MYO MONITORING REPORT

Swamp Grape Stream and Wetland Mitigation Site

Response to DMS Comments – Draft Baseline Document (MY0) and As-built Drawings
DMS Project No. 100115
Full Delivery Contract No. 7869
DMS RFP No. 16-007705
USACE Action ID No. SAW-2019-00904
DWR Project No. 2019-0675

Comments Received (Black Text) & Responses (Blue Text)

Swamp Grape Groundwater Gauge 11 Preconstruction (2021 Data)

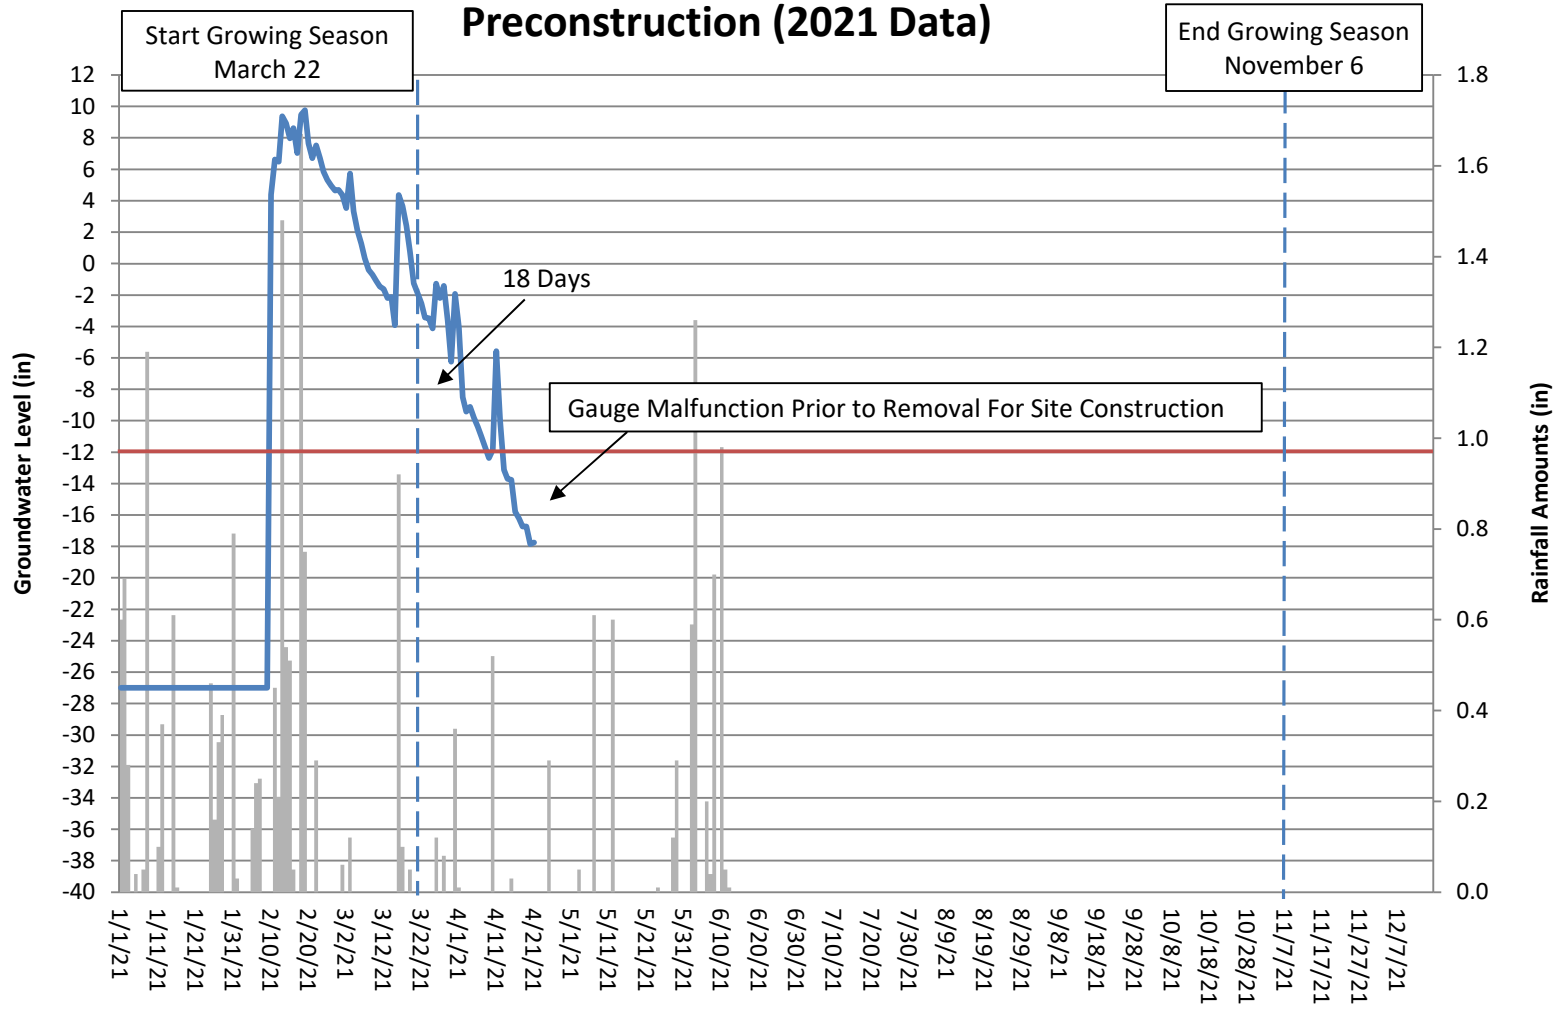
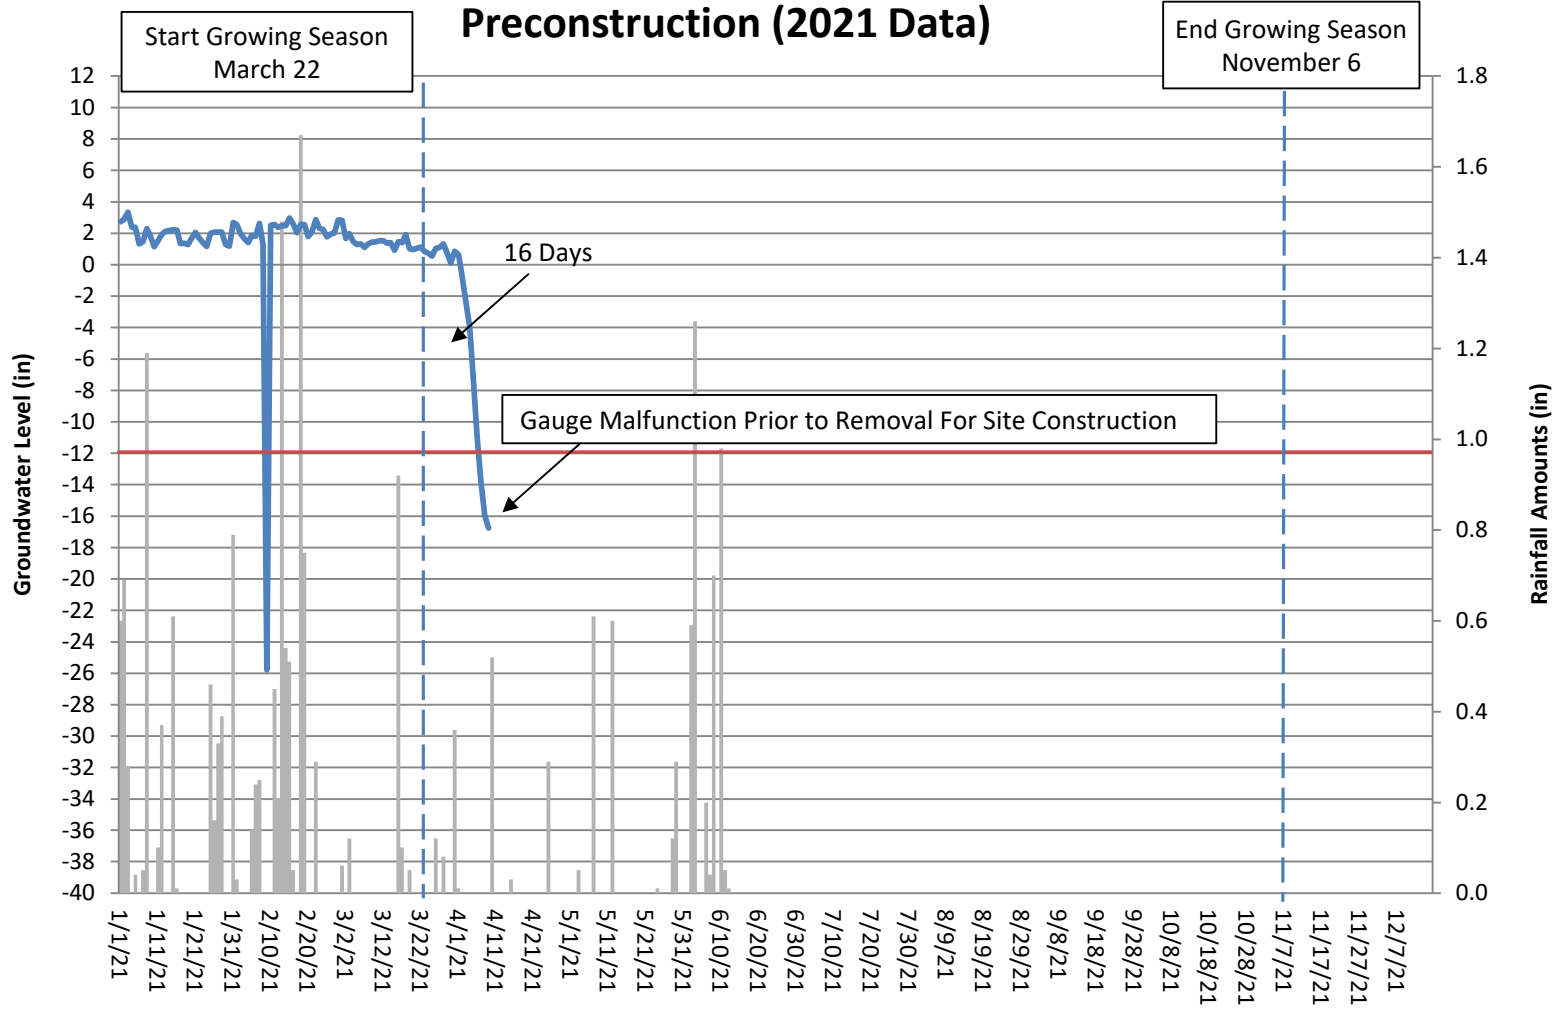
1. Cover pages: check USACE ID no; DMS has 2019-00904 in its records.
Response: The USACE ID was corrected to 2019-00904.
2. Present the 2021 pre-restoration groundwater gage data in the MY0 report.

Response: We have included the 2020 and 2021 pre-construction groundwater gauge data in Appendix D.
3. In the field, we discussed that the pre-restoration gages numbers were not the same as post-restoration gage numbers. Provide a map of the pre-restoration gage locations and numbers. It may be useful to provide a discussion of the 2020 and 2021 data for context.

AS-BUILT SITE GRADING
C3.00

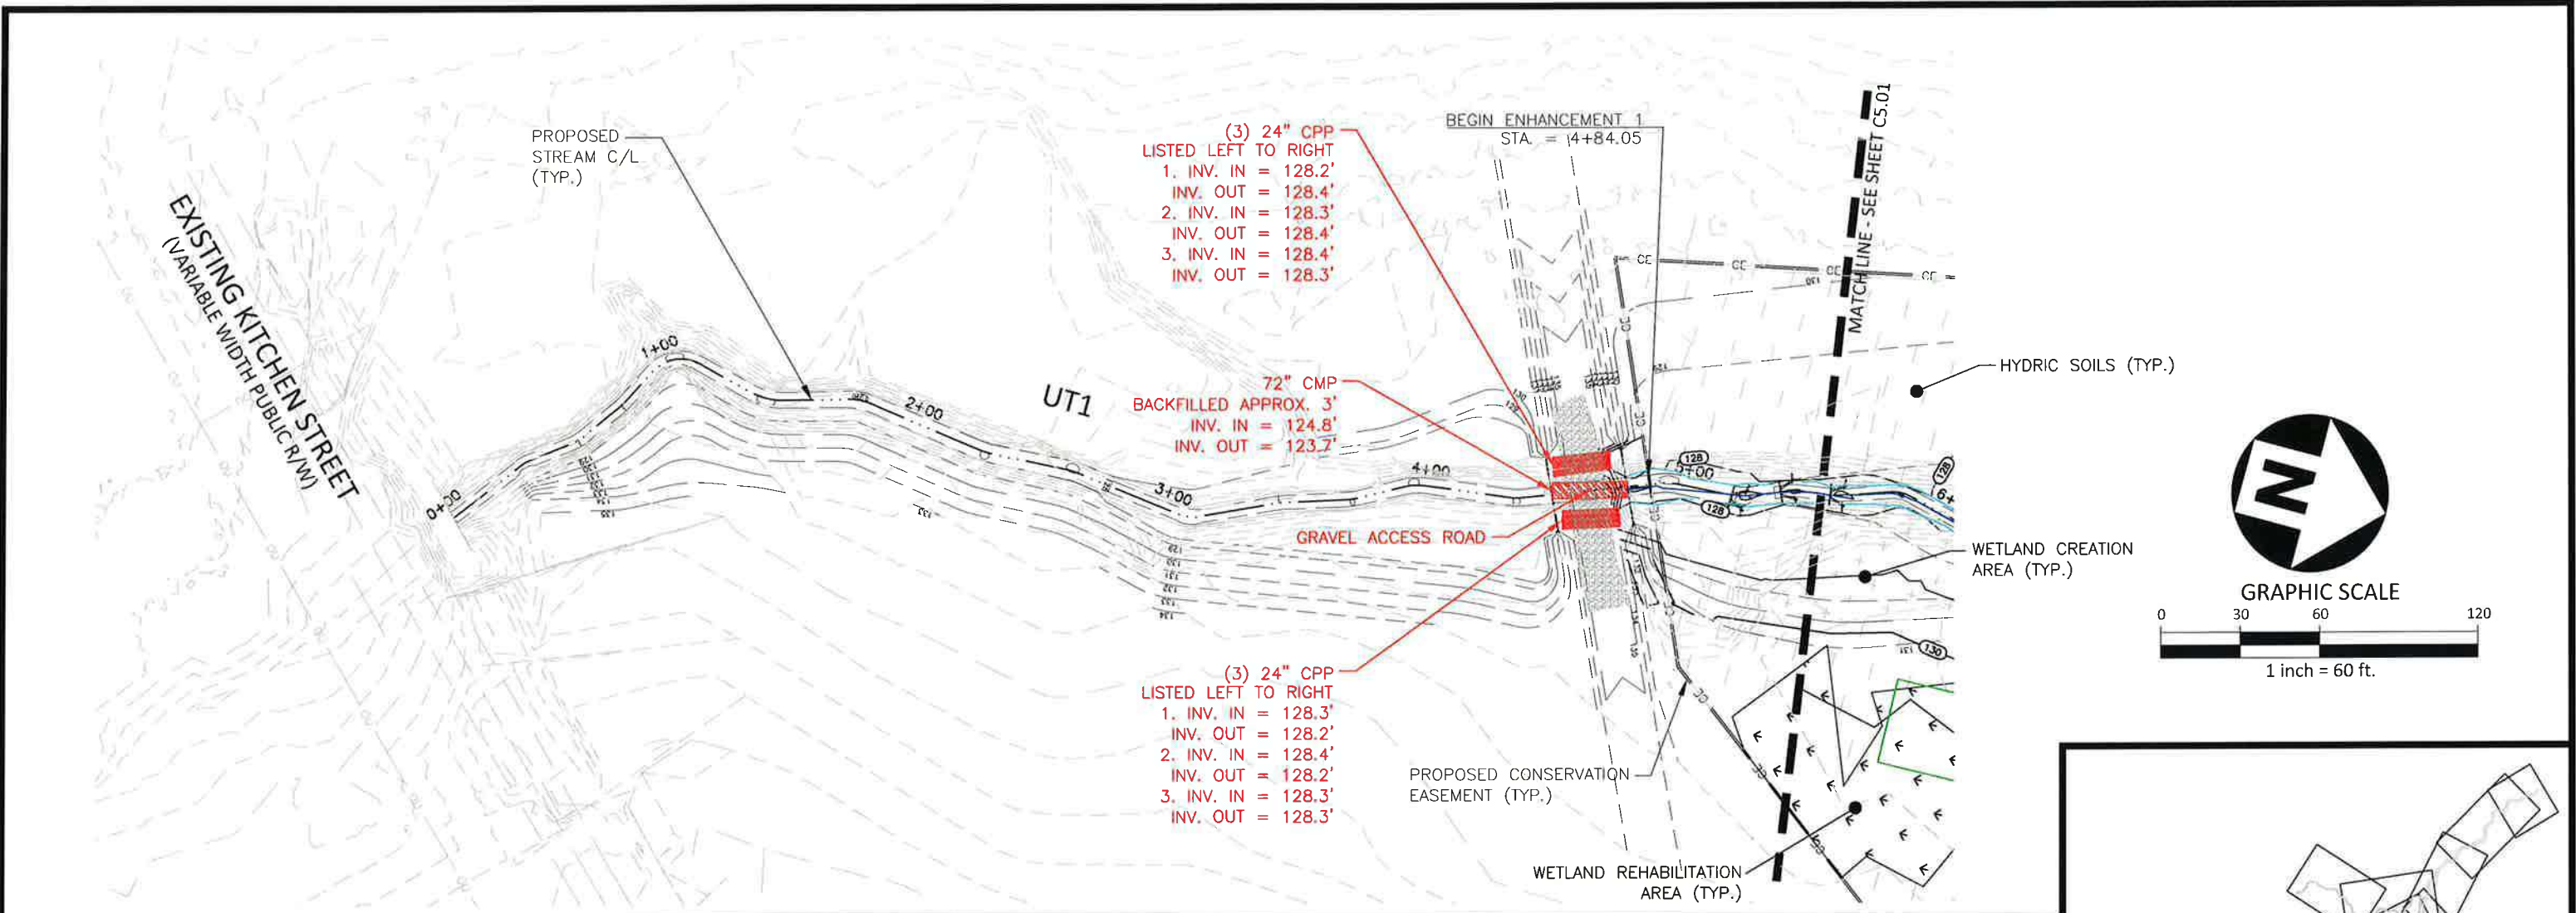
Response: The typo has been corrected.
9. Consider removing the as-built grading drawing that was discussed in the field. This may not be useful if it does not apply.

Response: We have removed the as-built grading drawing and replaced it with a figure showing topographic contour lines.
